Name: Montessori Day Care School - PR-8 - Revised Final Plan

REVIEW COMMENTS

TITLE HEADING: Revised Final Plan

ACTIVITY: Revised Final Plan in PR-8 Zone for a Daycare Center & School

DRAINAGE PLAN

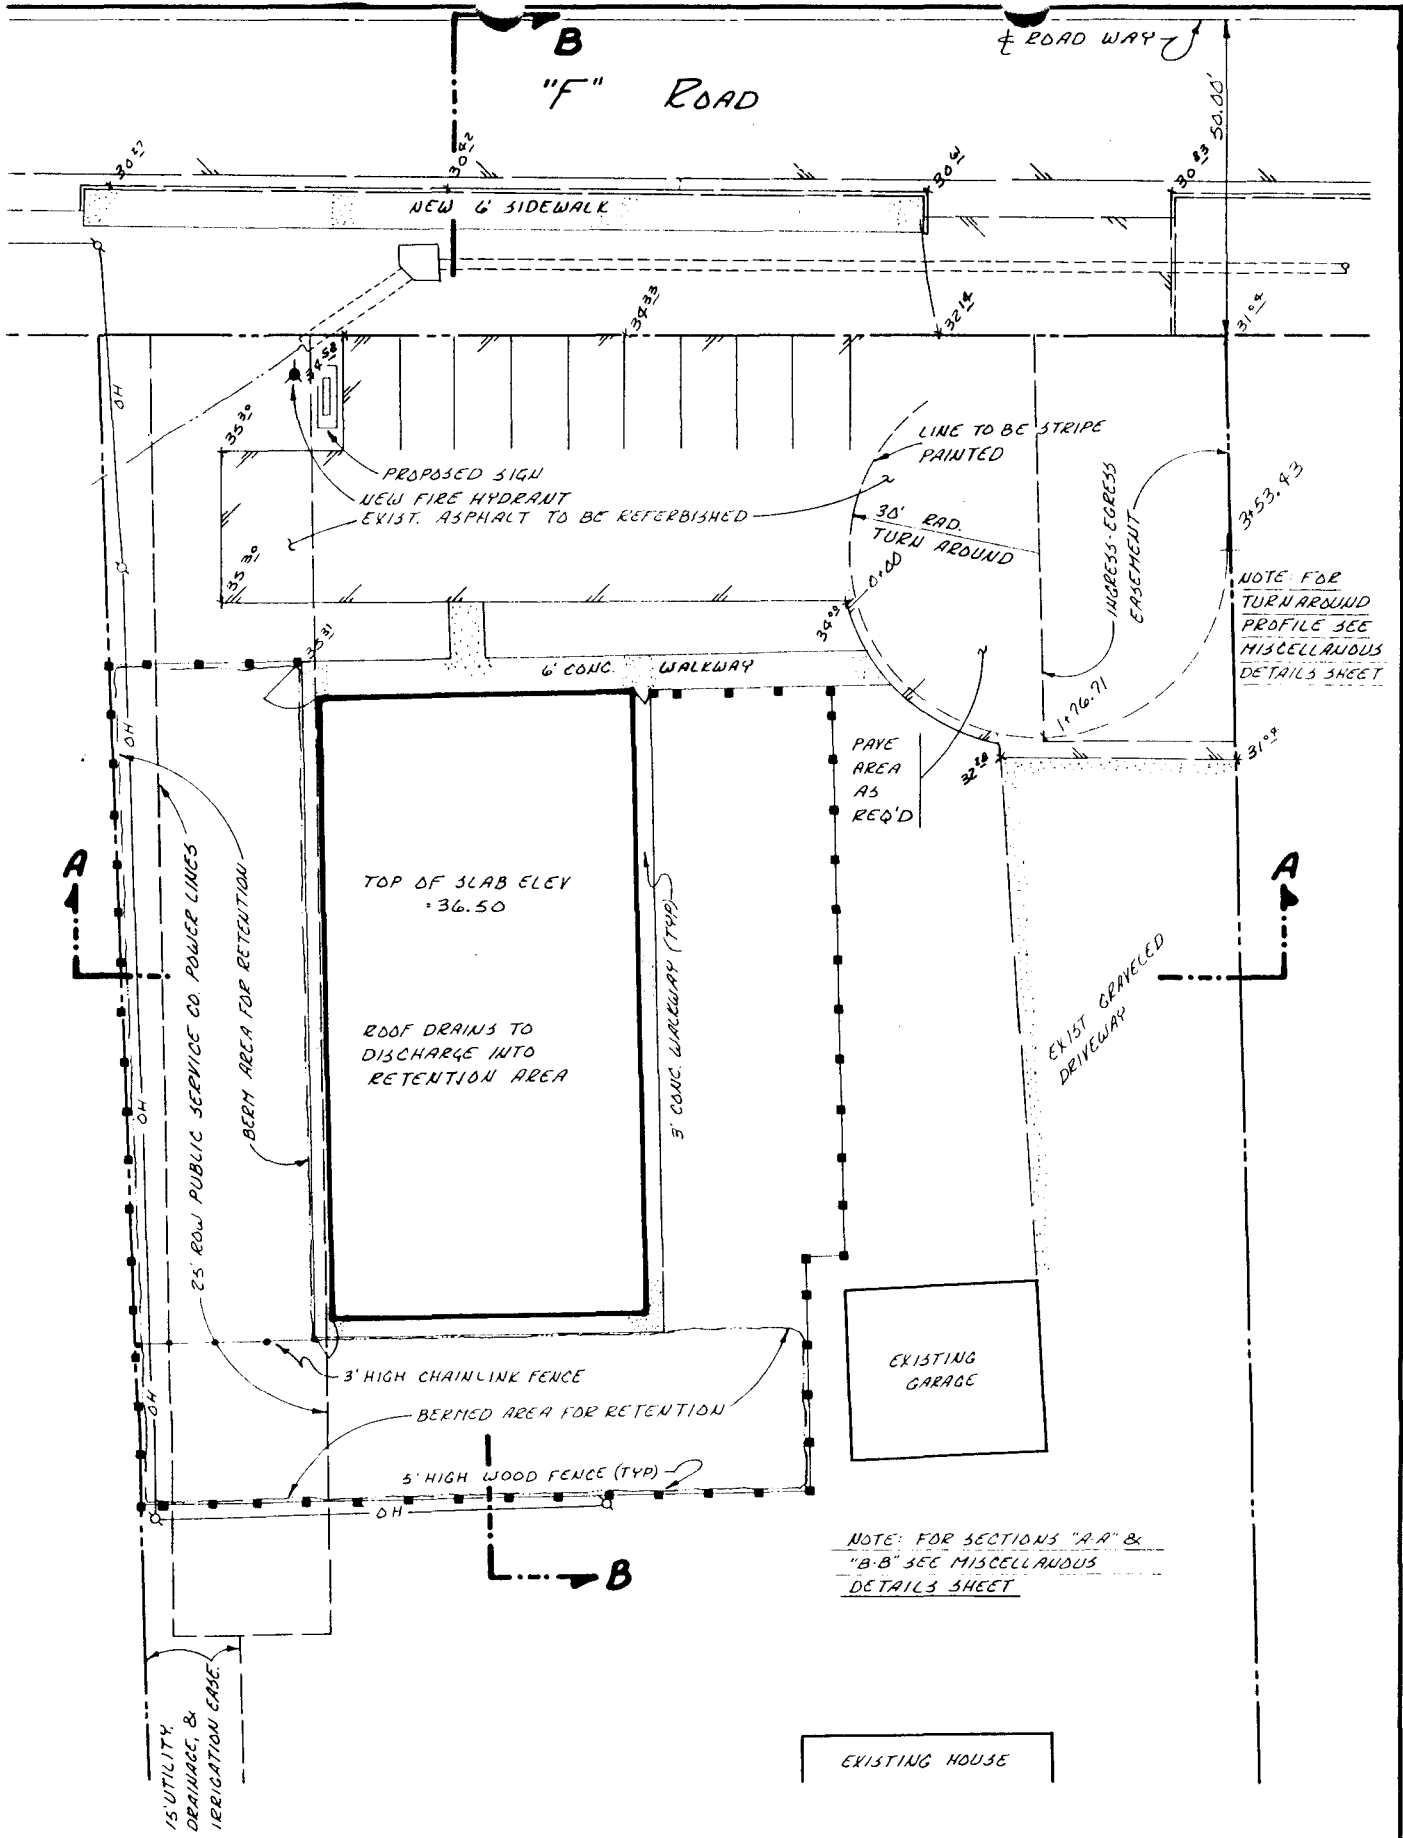
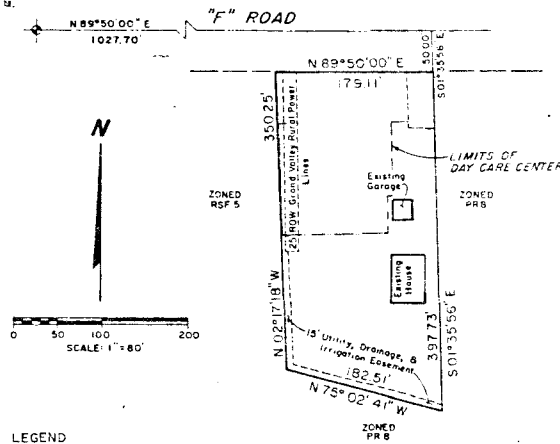
1. The drawing must show subbasins.
2. Developed runoff rates from the site may not exceed historic runoff rates from the site under ~~two conditions~~ as a whole or to individual ~~properties~~ private properties (unless written approval is received by affected parties). The drainage report does not address the above criteria. An area 1 and Area 2, which are not delineated, are discussed, but Area 1 does not coincide with the area contributing to the retention basin. Therefore, one must assume that the balance of Area 1 has direct runoff. Likewise for Area 2. It would appear ~~that~~ that under the developed condition, Area 1 consists of ~~0.5~~^{0.4} cfs direct runoff, and 0.5 cfs overflow runoff from a filled retention basin, and Area 2 contributes 0.6 cfs direct runoff for a total site runoff of 1.5 cfs, which exceeds the historic rate of 0.7 cfs. Also, the 0.6 cfs of Area 2, which goes to private property, exceeds the historic rate of 0.2 cfs.

5. Per the grading plan, much of the asphalt surface area will drain directly to the R.O.W. at an increased runoff rate due to development. This must be counteracted by reduced runoff elsewhere (as opposed to maintained runoff). ~~Keep~~ Keep this in mind when designing a detention or retention facility. ~~Retention (and catchment ponds) may be~~ ~~used as a mitigation with the amount of~~ ~~retention.~~ ^{Also,} retention is not allowed unless: submitted percolation tests indicate that the retained volume can be dissipated in 48 hours; a letter from a geotechnical engineer indicates that such ~~retention~~ retention can be mitigated by structural design; and that the volume is sized to prevent overflow until such time that other runoff is reduced, and the summation of runoff from the site is not more than in the historic condition.

6. The drawing shows a retention area that is 0.0' - 0.5' deep on one end and 0.0' deep on the (average of 0.25 feet)

other end. The average depth available is not 0.33 feet as shown on the drawing, but 0.125 feet deep. However, average end/area methods also overestimate volumes. The conic method is more suited to detention volumes, which is

~~You would be better off having a flat~~
You have plenty of area to work with to get retention volume — but your design does not provide it.

7. Proposed contours do not match proposed grades on parking lots. Contours on parking lots are not necessary either, so you may as well remove them.
8. Where is the entrance to the building? What are sidewalk grades and slopes? Do they meet handicap criteria? The proposed handicap

ramp needs more grades and definition. More grades are needed elsewhere too. See attached drawing.

After development, the site will have 4 subbasins which will drain North, East, South, and also provide retention on-site, ie., Area 1A - North, Area 2A - East, Area 3A - South, and Area 4A - Detention.

See attached plans for drainage subbasin locations.

SITE PLAN FOR
 MESA MONTESSORI CHILDREN'S HOUSE
 DAY CARE CENTER
 GRAND JUNCTION, COLORADO
 W.H. LIZER & ASSOCIATES
 ENGINEERING & SURVEYING
 576 25 ROAD - UNIT 8 - 241-1129
 GRAND JUNCTION, COLORADO 81505

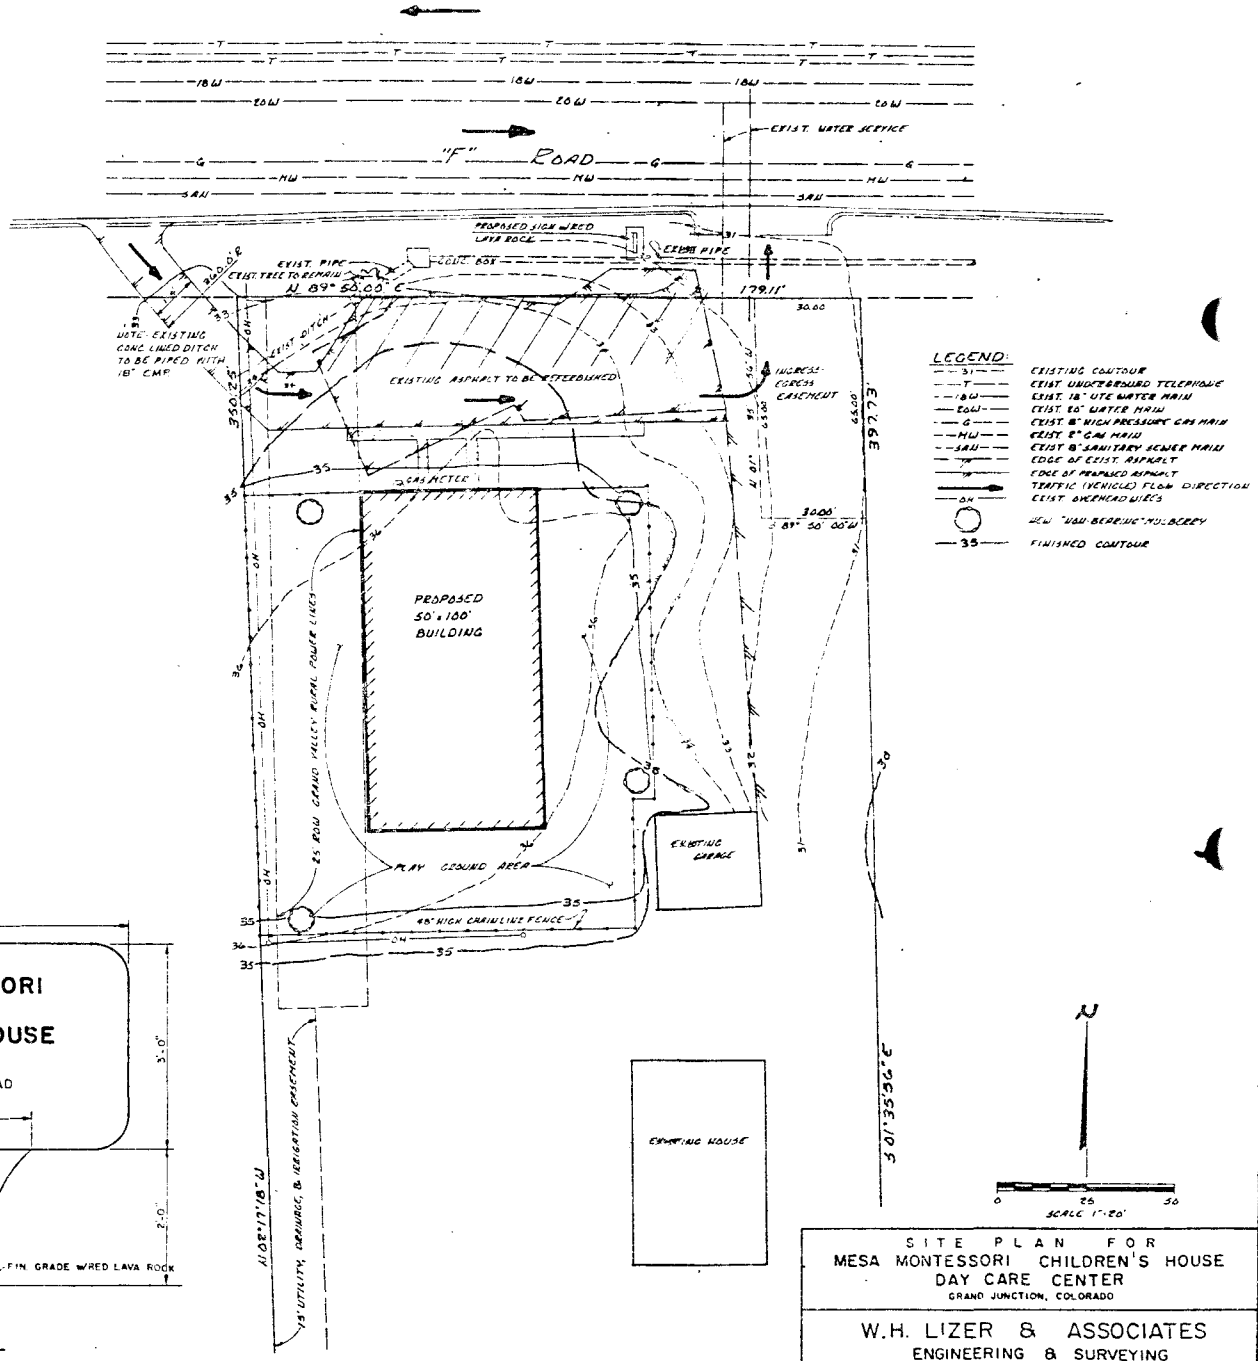
1. Connection to City water will need to be made from the south property line, not "F" Road. Existing water service as show is off Ute Water. City water available at south property line of lot.

1. Show location of sanitary sewer service line and how it will be affected by other utilities if put into the line in "F" Road.
2. An E.Q.U. of 2.16 will be applied to the proposed use if capacity as stated is 54.

3. Parking lot and entry/exit detail is lacking on the site plan. Please show dimensions and elevations.
4. An existing concrete ditch is shown to be piped under the driveway entrance with CMP. Written approval of the size and material type by the ditch owner must be submitted to the City. Also an easement or agreement is required for the driveway offsite.

8. Need one-way traffic control signs on driveways.
9. Parking space at east end encroaches upon exit driveway.
10. Landscaping plans are required.

1. One-way signing for access.
2. Easement for one-way entry.
3. Remove last parking stall closest to exit way as it encroaches into access.
4. No landscaping over 2 1/2 feet in right-of-way.

8. Parking stall must be at a 90° angle since traffic can potentially enter from either direction. You need to make sure enough room is provided for aisle width and parking stall width and length.
9. All Review Agency Summary Sheet comments must be properly addressed by the petitioner and a written response to our office is due at least 48 hours prior to the Planning Commission Hearing on May 5, 1992.

Near the NW corner of the site, this Association has an irrigation lateral of long standing. It is shown on the site plan drawing and is labeled existing ditch, to be piped with 18" CMP. Piping of the lateral is advisable in view of the site's proposed use and while 18" diameter pipe is acceptable, CMP is not, due primarily to its limited life-span and its susceptibility to penetration by tree roots at the joints or at pin holes once developed. Any pipe used must be approved by the Association and must have water-tight root-tight joints and be connected to the existing concrete pipe with an absolute root and water tight connection.

The existing tree shown on the site plan is water-loving willow and is feeding on the water from the open ditch. Its root system continually fills the ditch causing unreasonable, additional work and expense to keep the ditch functioning as evidenced by large piles of root mass shoveled from the ditch at that location. While objectionable, it is manageable in an open ditch, but not in a pipeline.

1. The service connection to the City of Grand Junction Water system is shown on the attached plans together with plans for a fire hydrant installation.

1. Onsite storm detention for roof runoff will be provided for a 10 year event. Drainage and grading plan attached.
2. Drainage and grading plan attached.
3. Dimensions, details, and elevations shown on attached plans.
4. Concrete pipe for existing ditch has been deleted from plans.
5. Sewer service shown on utility composite.
6. Sign moved to property side of development.
7. Six foot wide sidewalk along Patterson added to plans.
8. One way traffic pattern has been deleted from plans.
9. Parking area has been re-designed.
10. See attached landscaping plan.

1. One way deleted.
2. Easement deleted
3. Parking has been re-designed. See Plan
4. Landscaping in right of way is less than 2 1/2 feet high.
See landscaping plan.

1. "Mesa Montessori Children's House" sign relocated on the premises.
2. Appraisal attached.
3. Subsurface soil report attached.
4. 9 parking spaces shown on site plan.
5. Easement to the West has been deleted.

6. A six foot wide sidewalk along Patterson Road has been added to the site plan.
7. Revised landscaping plan is attached.
8. Parking angle has been changed to 90 degrees, with 25 foot aisle space.

1. Irrigation Lateral will not be piped as plan has been revised to delete one way traffic. Willow tree will be removed.
